APPLICATION NO.	FILING DATE	FIRST NAMED INVENTOR	ATTORNEY DOCKET NO.	CONFIRMATION NO.
10/587,445	07/25/2006	Dieter Ramsauer	STR-1013/500638.20035	5304
26418 7590 10/14/2009 REED SMITH, LLP ATTN: PATENT RECORDS DEPARTMENT 599 LEXINGTON AVENUE, 29TH FLOOR			EXAMINER	
			MORGAN, EMILY M	
NEW YORK, N	,	LOOK	ART UNIT	PAPER NUMBER
			3677	
			MAIL DATE	DELIVERY MODE
			10/14/2009	PAPER

Application No.	Applicant(s)	
	10/587,445	RAMSAUER, DIETER	
Office Action Summary	Examiner	Art Unit	
	EMILY M. MORGAN	3677	
The MAILING DATE of this communication ap Period for Reply	opears on the cover sheet with the	correspondence address	
A SHORTENED STATUTORY PERIOD FOR REPLAY WHICHEVER IS LONGER, FROM THE MAILING ID. - Extensions of time may be available under the provisions of 37 CFR 1 after SIX (6) MONTHS from the mailing date of this communication. - If NO period for reply is specified above, the maximum statutory period. - Failure to reply within the set or extended period for reply will, by statuding the period for reply will, by statuding reply received by the Office later than three months after the mailing earned patent term adjustment. See 37 CFR 1.704(b).	DATE OF THIS COMMUNICATION 1.136(a)

Please see the designations of figure 5, as shown below. Young discloses a singular inclined surface on each holding part, which allows for easy insertion. Young does not disclose a second inclined surface.

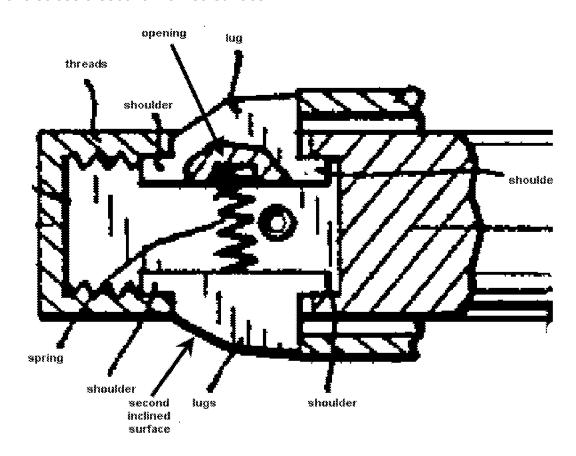
(figure 5) and whose free end has a second inclined surface 42 which enables the holding part and the body part to be pushed through the opening, the inclined surface being inclined with respect to a plane of the thin wall (figure 1);

wherein the holding elements (lugs) are formed by two flat metal pieces lying next to one another, each metal piece having a rectangular opening or breakthrough (for the lug to expand through the surface of the attachment device), these two openings or breakthroughs together forming a rectangular space which receives a spiral pressure spring 41 by at least a portion of its diameter.

The '185 Ramsauer device using the Young connecting article discloses the claimed invention except for the first inclined surface. It would have been obvious to one having ordinary skill in the art at the time the invention as made to incline both the surfaces of the lug 40, a change in the shape of a prior art device is a design consideration within the skill of the art. *In re Dailey*, 357 F.2d 669, 149 USPQ 47 (CCPA 1966). Since the '159 Ramsauer reference uses the two inclined surfaces for the purposes of ensuring a secure connection ("without play"), it would have been obvious to apply this to a connecting article. This is also the same purpose that the instant application [0086] uses the inclined surfaces. This is a known reason and purpose for this the change of shape for a similar article.
